SYNGENE INTERNATIONAL LTD, VELANKANI TECH PARK, ACCESSIBILITY AUDIT REPORT

PREPARED BY SVADHIN SOLUTIONS

GROUND FLOOR, SYNGENE INTERNATIONAL, VTPL – ACCESSIBILITY OVERVIEW

- The workstation storage pedestals as well as storage cabinets need braille labels as when people with visual impairment are hired in those areas

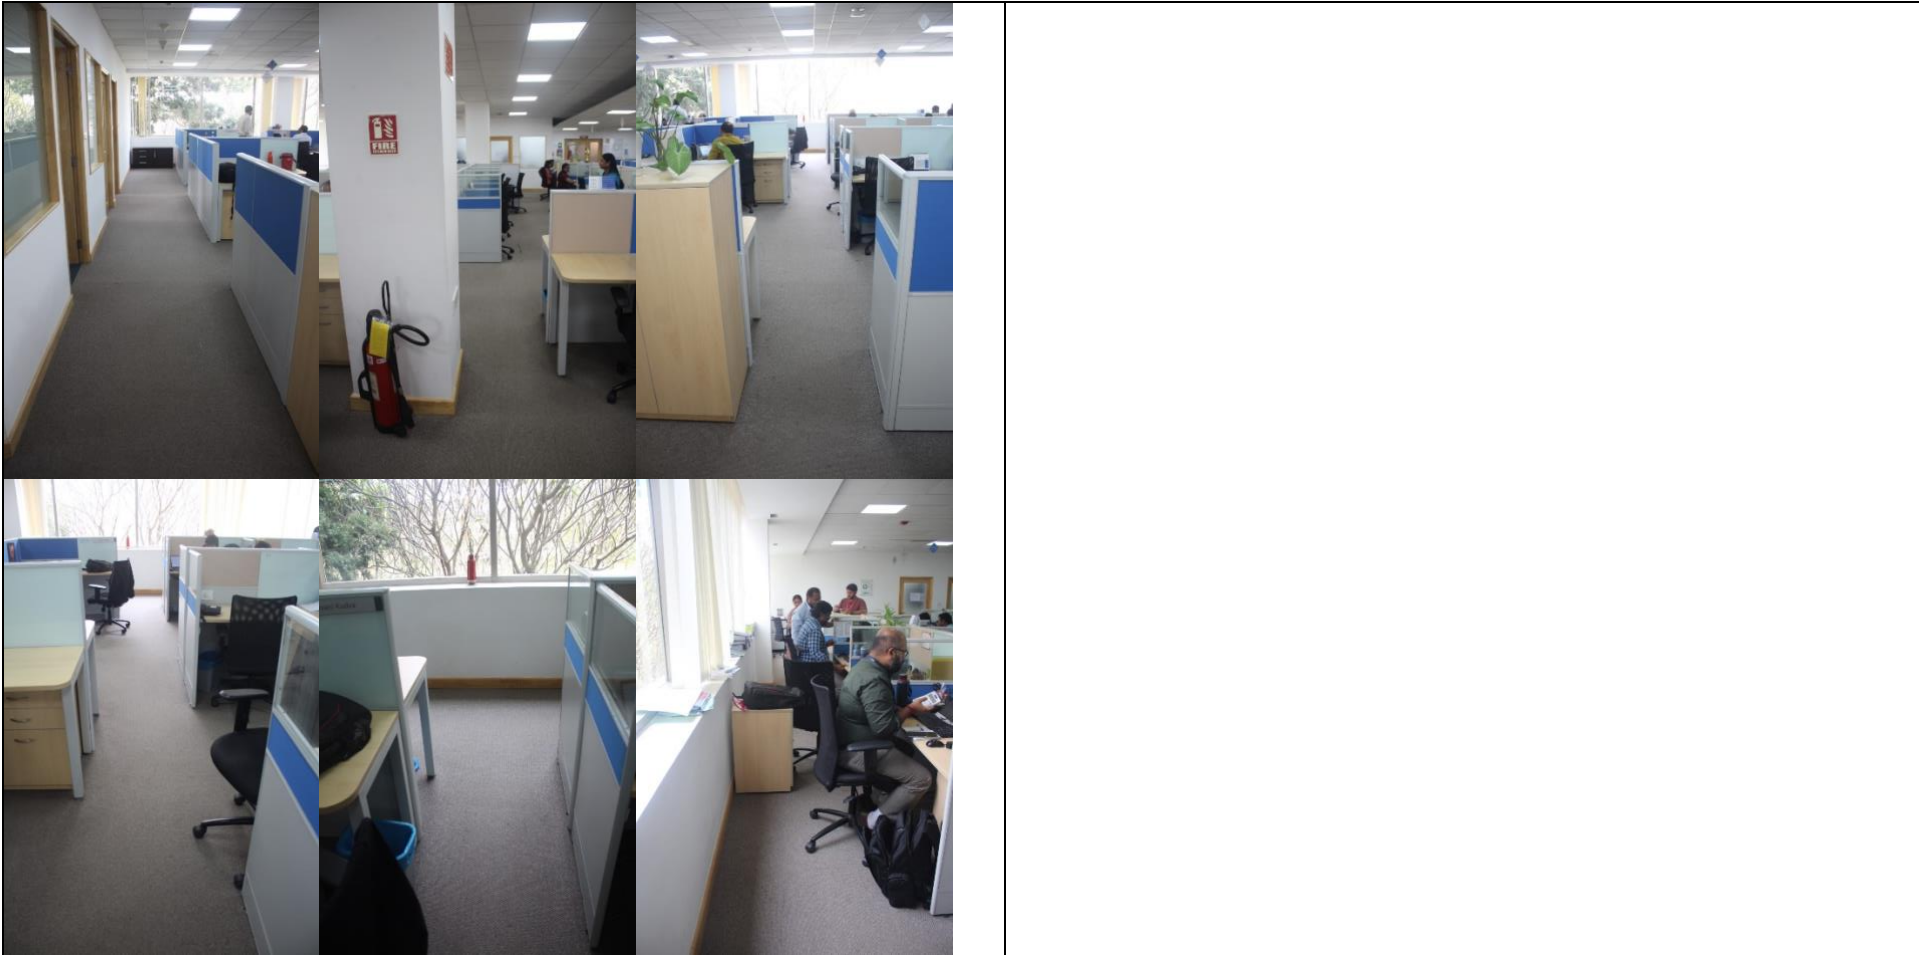
➤ A lot of points in the circulation paths and cubicle entries across the work floors have inaccessible widths as marked in the floor plans which will make the areas beyond these points completely inaccessible for PwDs

- A lot of points in the circulation paths and cubicle entries across the work floors have non-compliant widths and some of the pathways around the work seating in the circulation paths have practically hard to navigate widths as marked in the floor plans and will act as roadblocks for PwDs making these areas practically difficult for PwDs to navigate around

- Most of these inaccessible, hard to navigate and non-compliant circulation path widths and points have been created because of the placement design of the work stations not accommodating movement space required to move in a particular area

- There are multiple seats across the work floors that have inaccessible and/or non-compliant chair clearances as marked in the floor plans and will be inaccessible for certain PwDs

- Some of the work area passages have storage units and/or printers placed that compromise the passage width there as well as compromising access space required for the storage units and the printers

- The linear style workstations have keyboards that compromise knee clearances for wheelchair users making these workstations inaccessible to use
- The workstation storage pedestals as well as storage cabinets are inaccessible for people with certain types of hand impairment because of the locking mechanism and handle type

PWD RESTROOMS	
	➤ There is no PwD restroom in the third floor at all making this floor non-compliant and completely inaccessible for certain PwDs

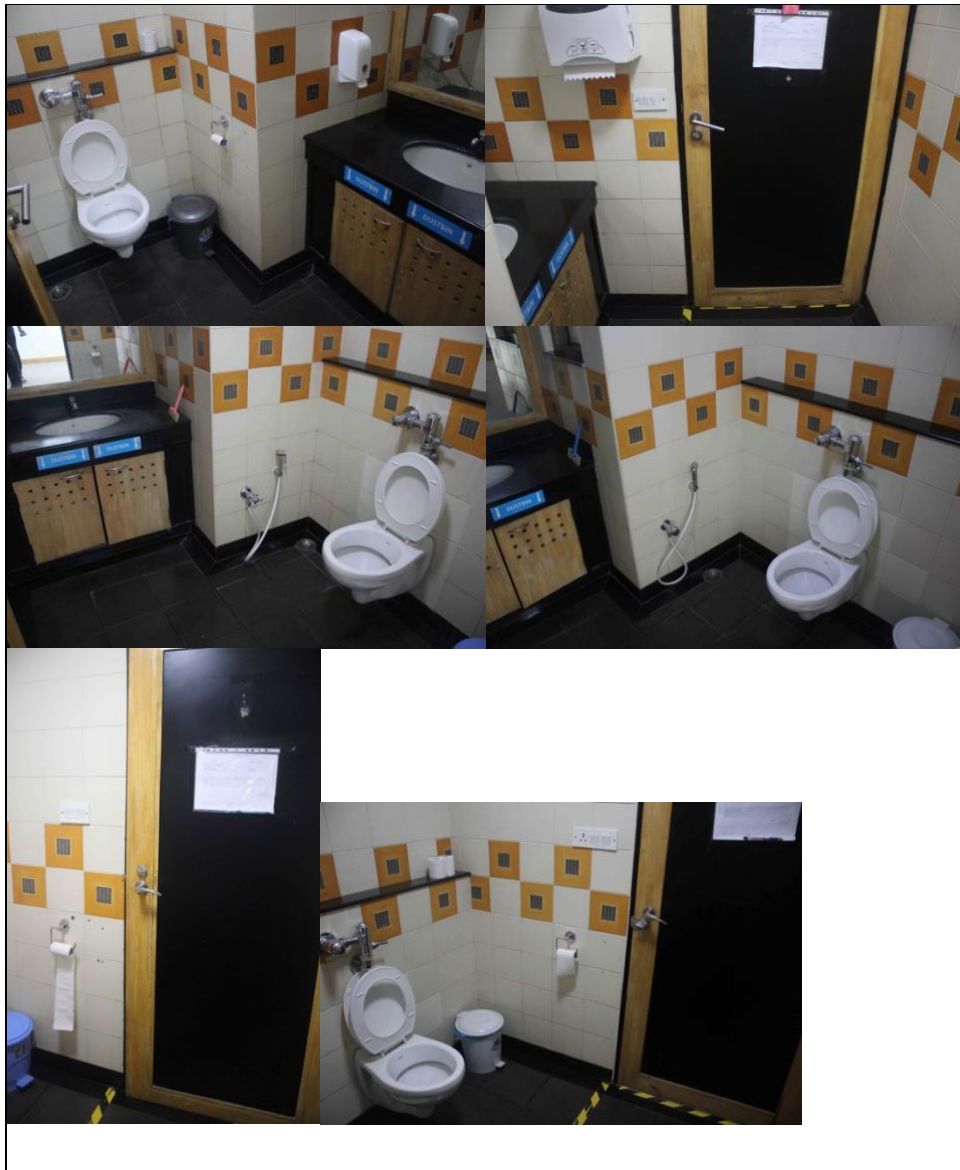
- The ground floor PwD restroom access is via a corridor that has non-compliant path width
- All three PwD restrooms have signage placed at non-compliant heights with no provisions for braille and tactile and inappropriate text and symbols making these signage and the identification process non-compliant and inaccessible

- All three PwD restrooms have high door tension making them inaccessible for PwDs
- All three PwD restrooms have non-compliant dimensions and fixtures placed in a layout that compromises circulation inside the room as well as the transfer space for wheelchair users making all three restrooms completely inaccessible for PwDs

- All three PwD restrooms have inward opening doors with no push bars and kick plates and inaccessible type of hand sink taps making them non-compliant and inaccessible for PwDs

- All three PwD restrooms don't have the required supportive aids for WC and hand sinks with 38-45 mm diameter as required by compliance, accessible hand sinks, emergency alarms and accessible 30 degree tilt mirrors as per compliance making them inaccessible for PwDs

- The first and second floor PwD restrooms have non-compliant door widths, ground and first floor PwD restrooms have non-compliant handle heights and the ground floor PwD restroom has inaccessible pull side door clearance making these entries non-compliant and inaccessible for PwDs

MEN'S & WOMEN'S RESTROOMS

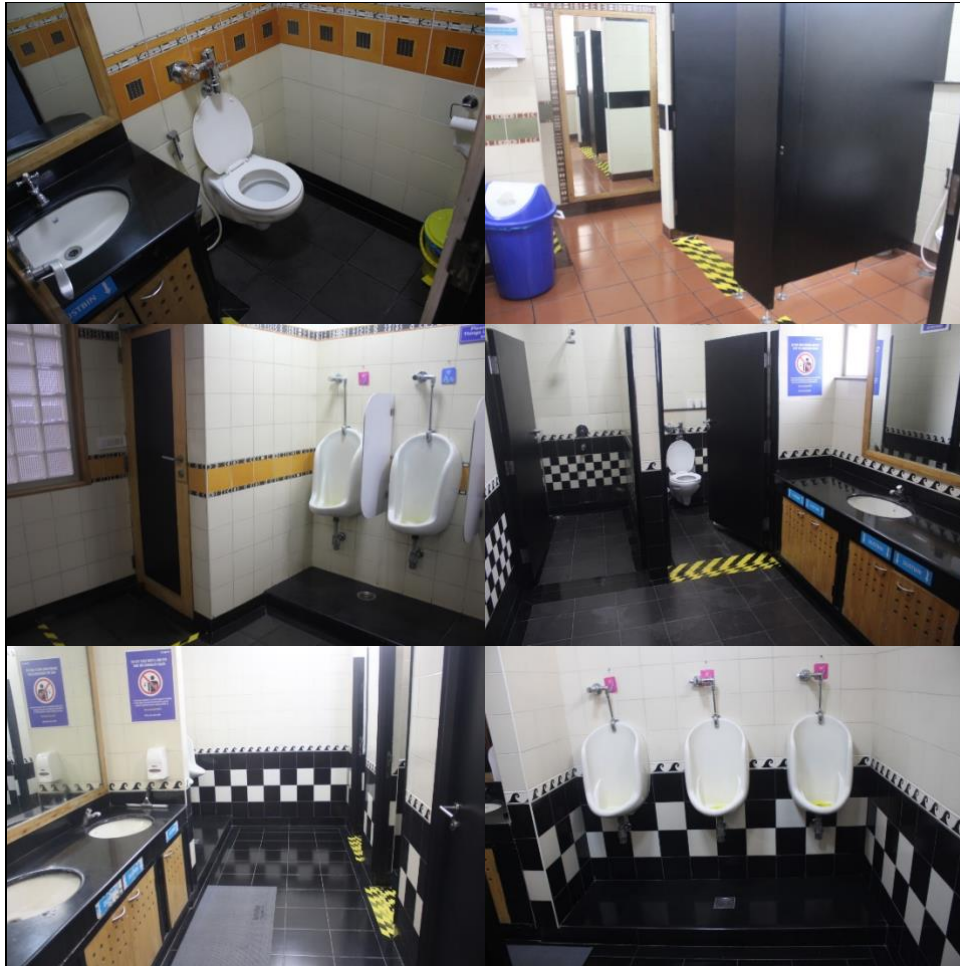
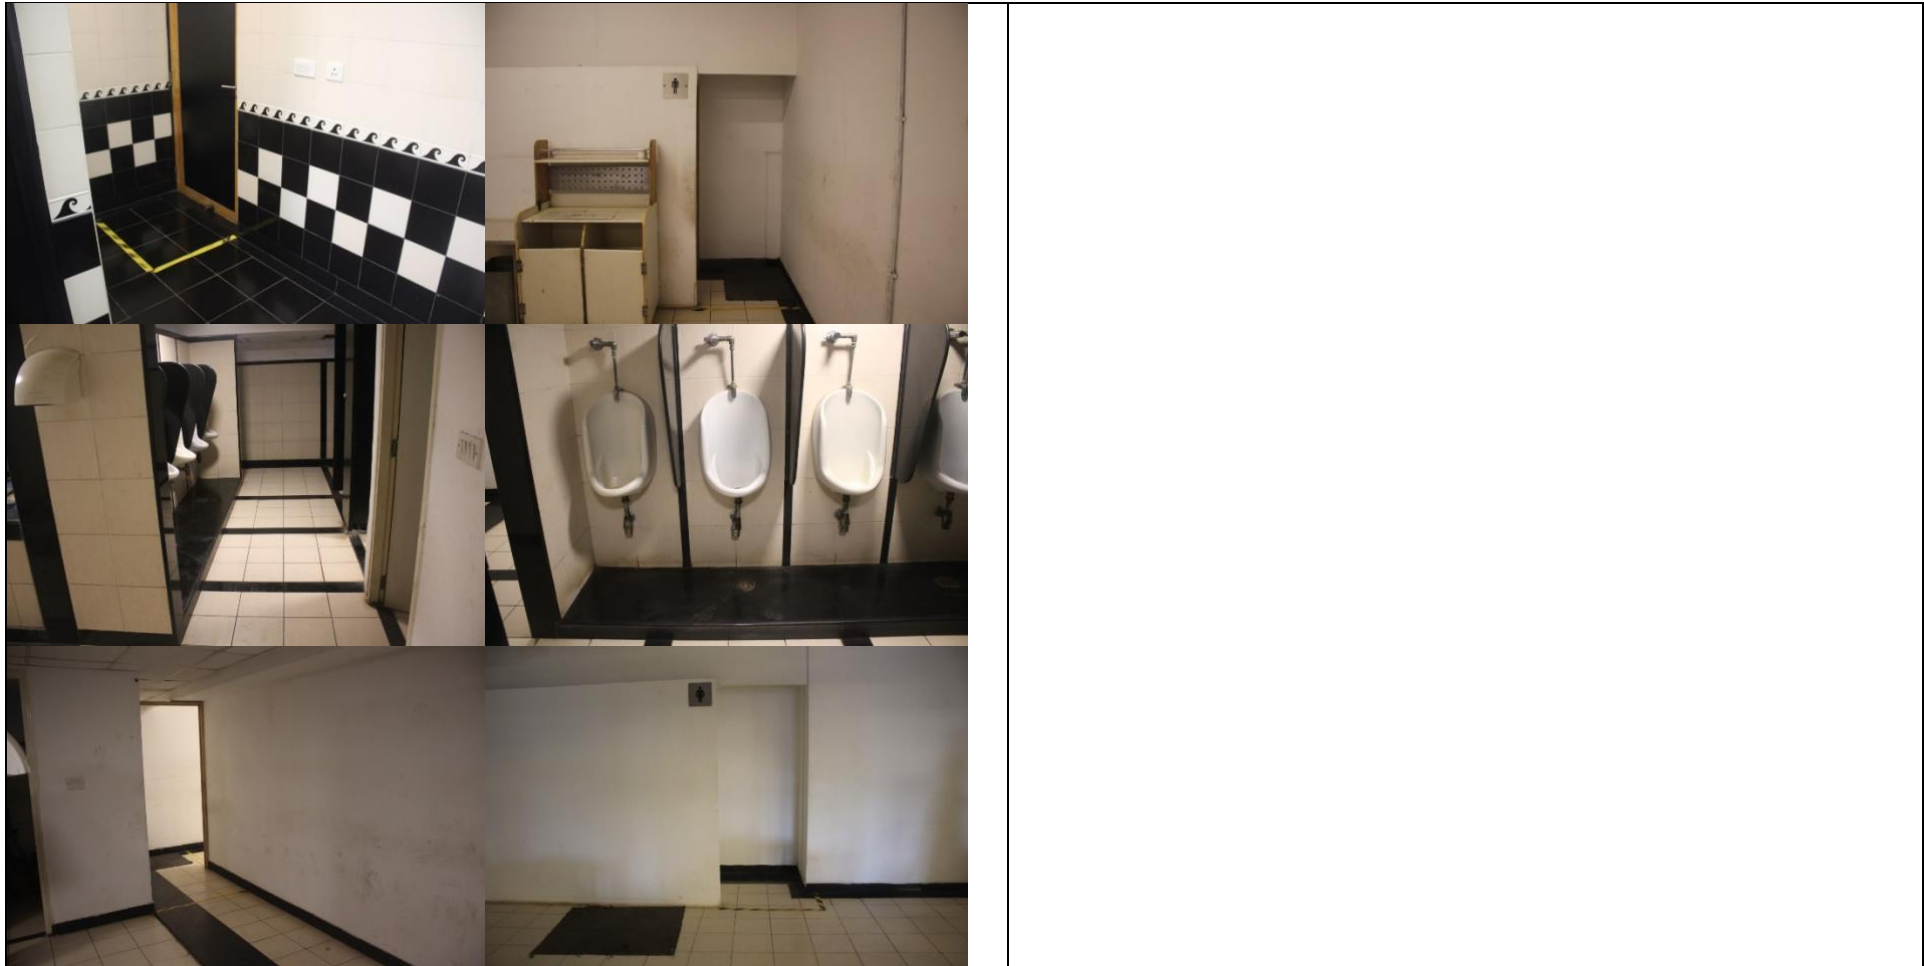
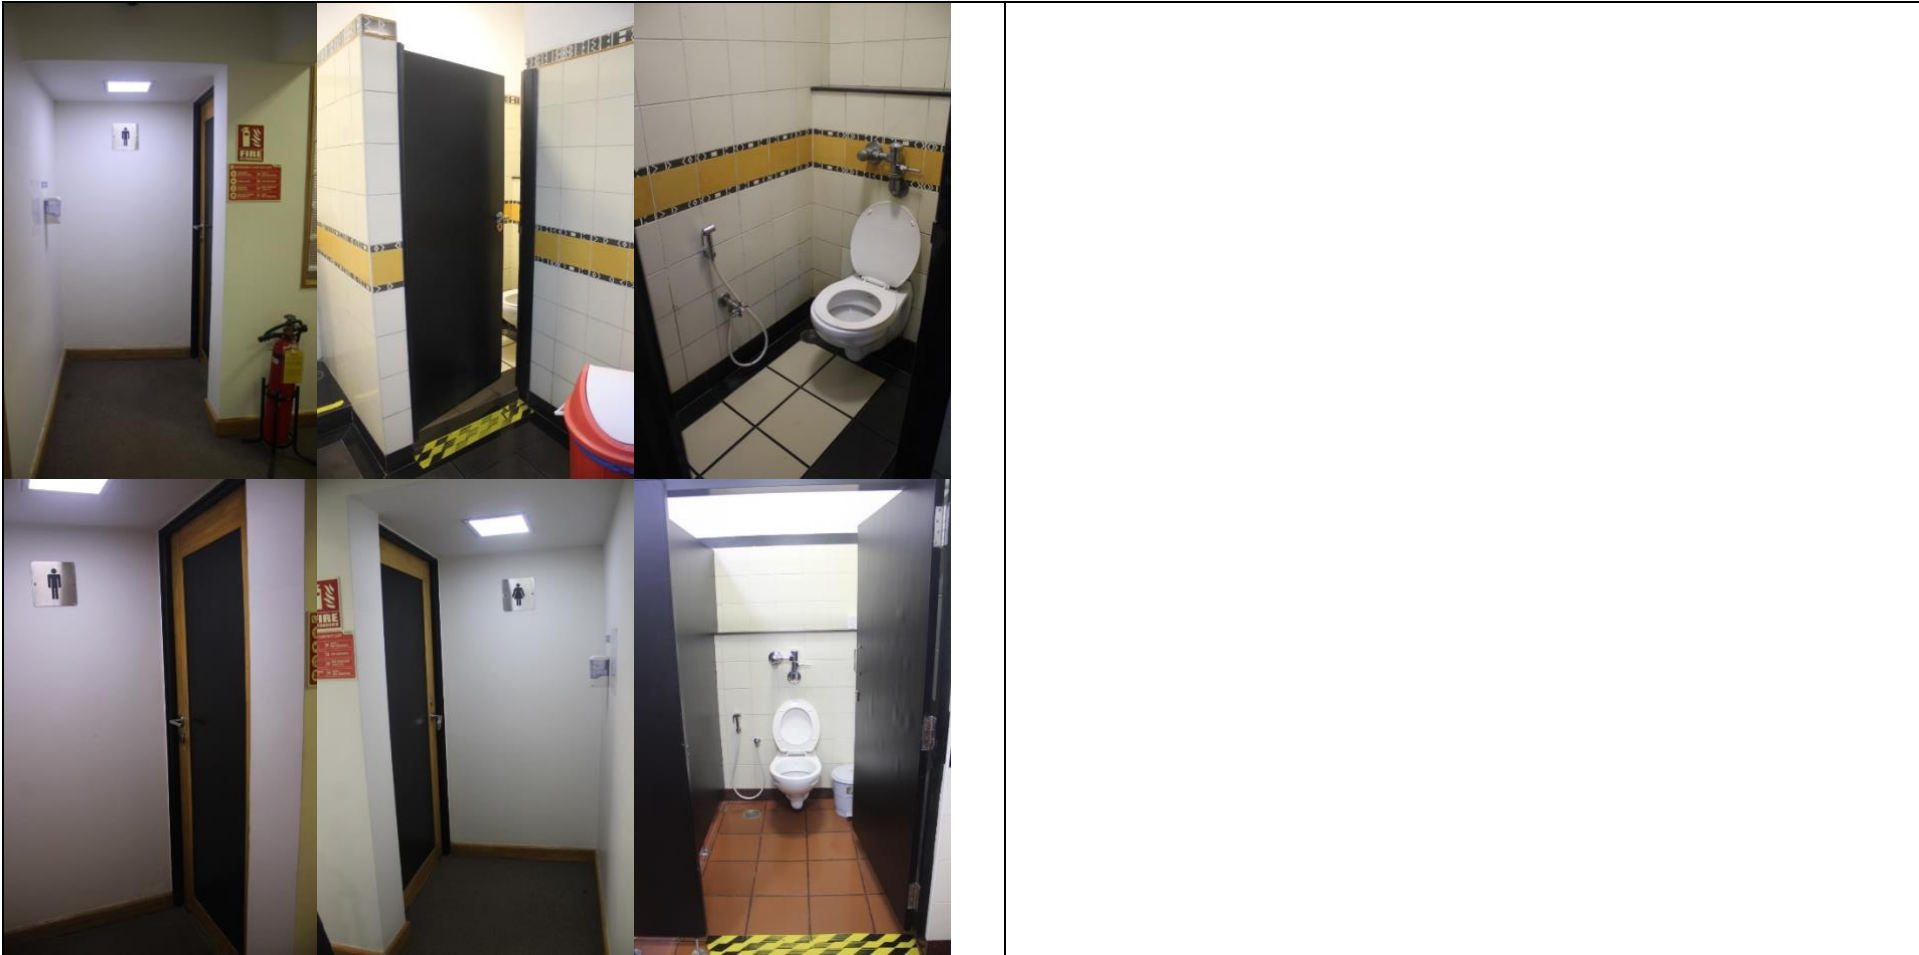
<ul style="list-style-type: none"> ➤ All the men's and women's restrooms' in the office building have entry doors with high door tension, non-compliant and/or inaccessible door widths, handles placed at non-compliant heights, and signage placed at non-compliant to inaccessible heights with no provisions for braille and tactile making these entries non-compliant and inaccessible for PwDs ➤ All the women's restrooms' in the office building have inaccessible pull side door clearances making them inaccessible for people with ambulatory disabilities ➤ All the men's and women's restroom entry doors in the office building have minor ledges at entry doors that can be unsafe for people using mobility aids ➤ Both the first and second floor conference room toilets have high door tension, inaccessible door widths, non-compliant handle heights, and
--	---

<p>signage with no provisions for braille and tactile making entry to these toilets non-compliant and inaccessible for certain PwDs</p>
<p>➤</p>	<p>The first floor conference room toilet does not have pull side door clearance and the tissue paper holder placed in the niche acts as a projection making it unsafe and the entry inaccessible for certain PwDs</p>
<p>➤</p>	<p>Both the first and second floor conference room toilets are congested and will be hard for certain PwDs to use these restrooms</p>
<p>➤</p>	<p>Both the canteen men's and women's restrooms have signage placed at inaccessible and non-compliant heights with no provisions for braille and tactile making these entries non-compliant</p>
<p>➤</p>	<p>All the men's restrooms have urinals at step levels that makes them harder to access and use for people with ambulatory disabilities and additionally reduces the clear space in front of the urinals for access making them non-compliant and inaccessible</p>

<p>➤</p>	<p>None of the men's restrooms have an accessible urinal at an appropriate height with supportive aids as required by compliance making it hard for people with ambulatory disability to use restroom facilities</p>
<p>➤</p>	<p>Neither of the men's or women's restrooms have a provision for one ambulatory disabled-friendly cubicle per restroom and are inaccessible additionally because of the inward opening doors, inaccessible entry door widths, non-compliant handle types or heights and lack of supportive aids for the ambulatory disabled making them non-compliant and inaccessible for the ambulatory disabled</p>
<p>➤</p>	<p>All the restrooms have slippery floors that can be unsafe and are non-compliant</p>
<p>➤</p>	<p>Some of the restrooms have hand dryers and/or tissue paper holders placed at points where they act as projections and can be unsafe for PwDs and are non-compliant</p>
<p>➤</p>	<p>Some of the restrooms have loose mats near the entry doors or hand sinks which can be unsafe for certain PwDs and are non-compliant</p>

- None of the restrooms have blinkers connected to the emergency system in case of an emergency as required by compliance
